UNITED STATES PATENT AND TRADEMARK OFFICE

APPLICATION NO.	FILING DATE	FIRST NAMED INVENTOR	ATTORNEY DOCKET NO.	CONFIRMATION NO.
09/683,354	12/18/2001	Joseph Neyman	neyman	3946

# Office Action Summary

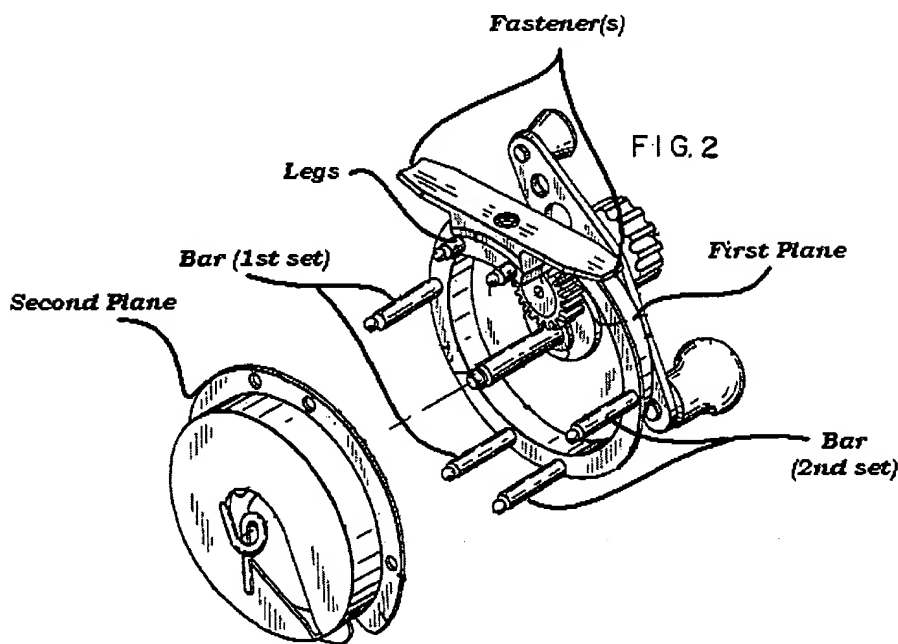
Dennison discloses a fishing line apparatus comprising a first plane, a set of bars communicating with the first plane, a series of legs, communicating with the first plane and a second plane communicating with the set of bars (see detail below); further comprising a second set of bars wherein the set of bars and second set of bars are disposed on opposite ends of said first and second plane (as the first and second set of bars are mirror images of each other, they are construed to be on opposite ends); wherein the set of bars creates a curvature at one end of the first and second plane, from the middle to the exterior, and the second set of bars creates a curvature at the second end of the first and second plane (i.e. the bars lie on an arcuate path) and comprising a hollow space between the first and second series of bars (seen in the

figure); further comprising a series of fasteners communicating with the series of legs (considered a series, i.e. more than one, in that each end of the fasteners communicate with separate structures of the reel seat assembly thereby producing two separate points of fastening); wherein the series of fasteners removably communicate with the fishing rod; further comprising indentations (i.e. the holes for receiving the first and second set of bars); wherein the fishing line can be wrapped around said first and second series of bars; wherein the series of bars is a means for wrapping a fishing line (and more generally a rope or thread) for storage and use. Regarding claim 15, while not stated in the disclosure, it is possible for a hook to be placed in the hollow space for storage.
